緯創資通	**Wistron Corporation** 21F, 88, Sec.1, Hsin Tai Wu Rd., Hsichih, Taipei Hsien 221, Taiwan, R.O.C.	
Title	*USB Card Reader Controller - RTS5158*	
Size / Document Number	Ferrari 7	Rev SB
Date: Monday, June 25, 2007	Sheet 1 of 1

Ferrari 7 Cardreader Schematic EC Tracking Record (For SA) Jun.15 , 2007
EC #/ Page / Description / Part Affected

Title		
	EC CHANGE LIST	
Size	Document Number	Rev
	Ferrari 7	SB
Date: Monday, June 25, 2007	Sheet 1 of 1

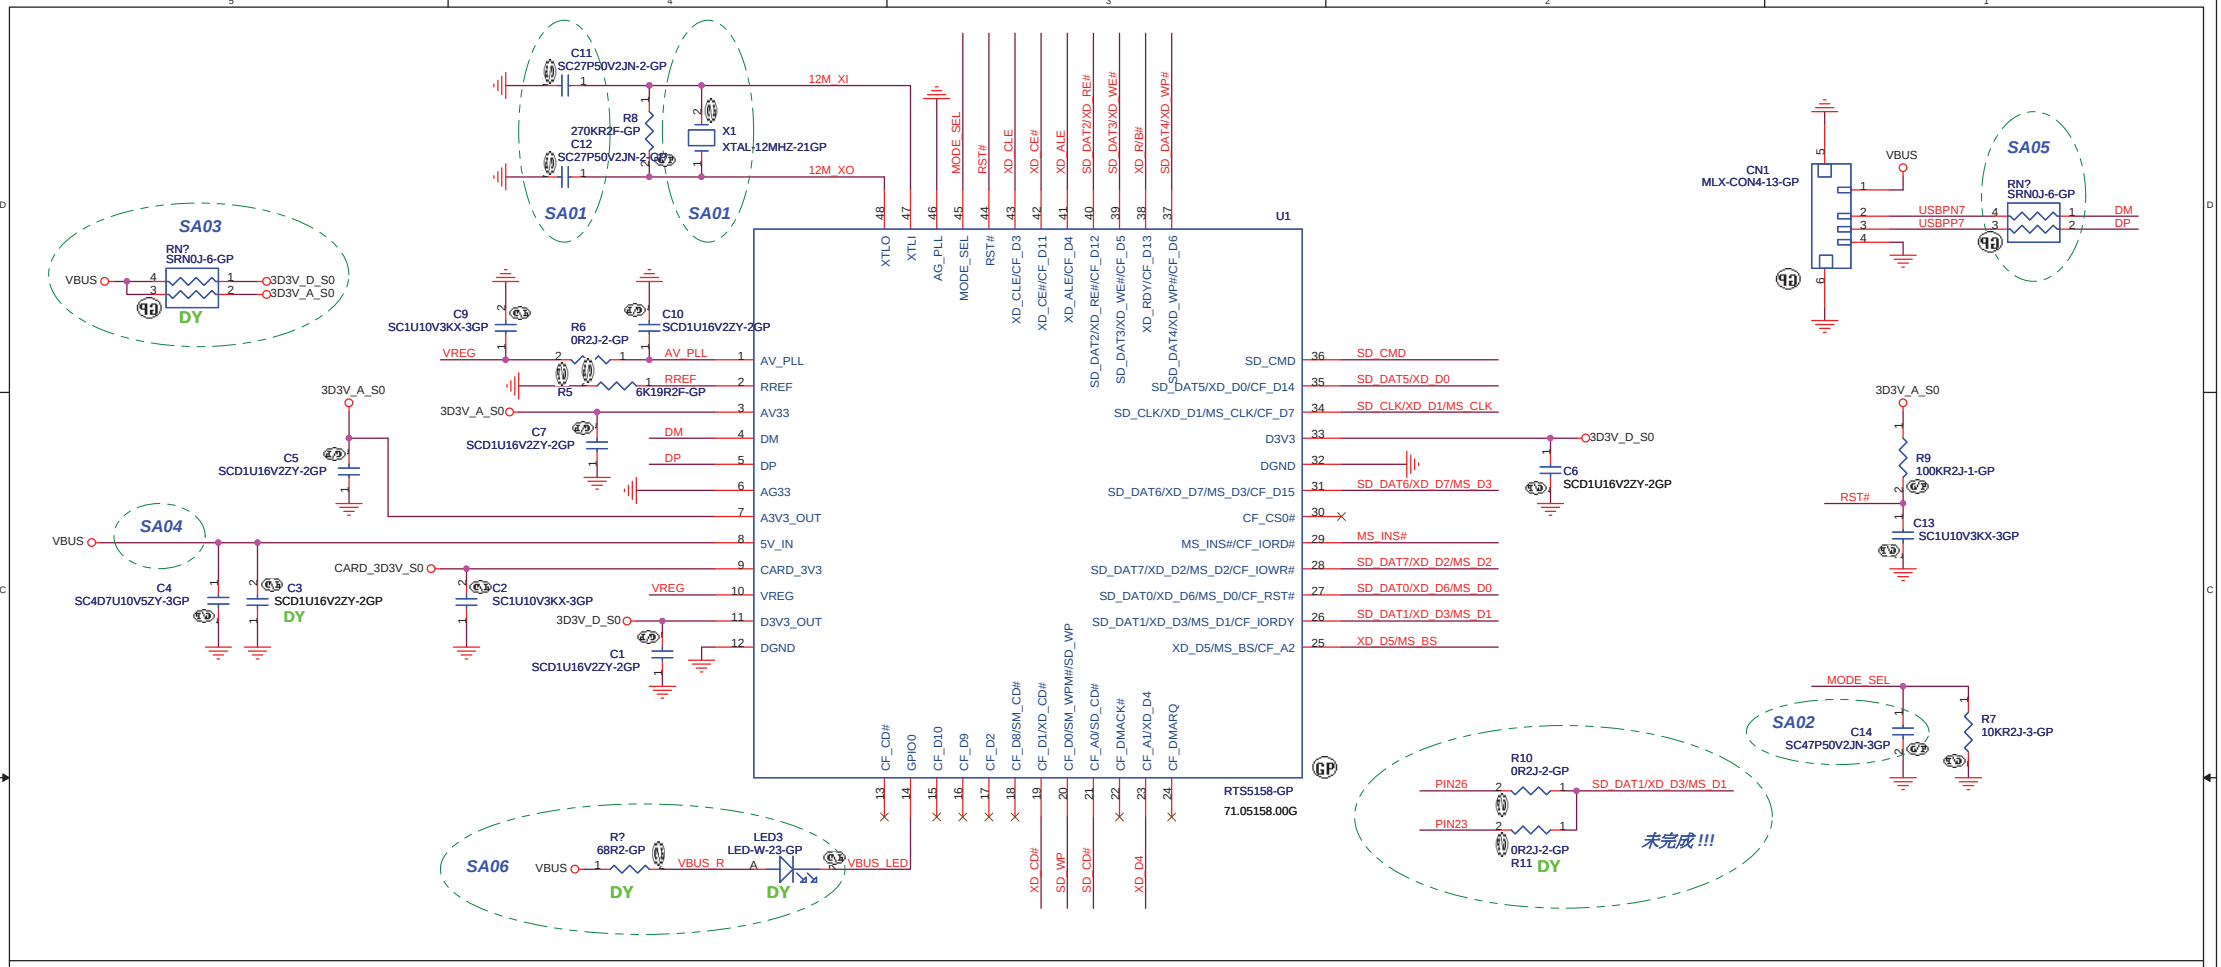
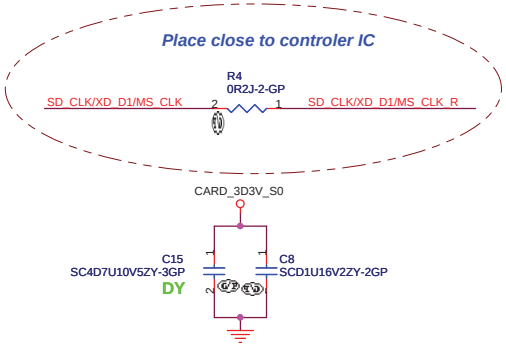
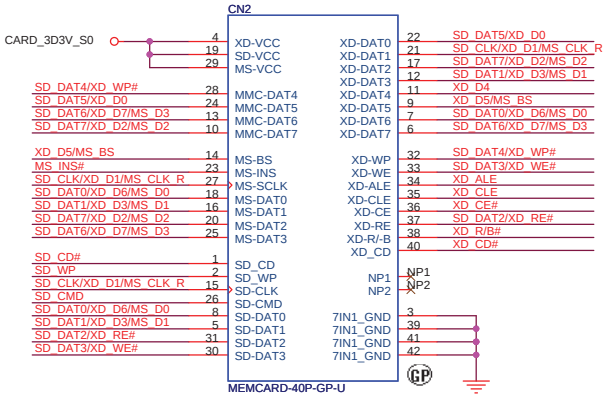
EC SA01/01/ 1. Change X1 P/N from "82.30006.261" to "82.30006.271", the reason is reduce package size.
2. Change C11,C12 from 20pF to 27pF for crystal accuracy.

EC SA02/01/ Change C14 from 0.1uF dummy to 47pF.

EC SA03/01/ Reserve for VBUS=3.3V input.

EC SA04/01/ Delete R3 resistor, the reason is reduce component count.

EC SA05/01/ Delete R1,R2 resistor, the reason is reduce component count.

EC SA06/01/ Reserve for debug use.
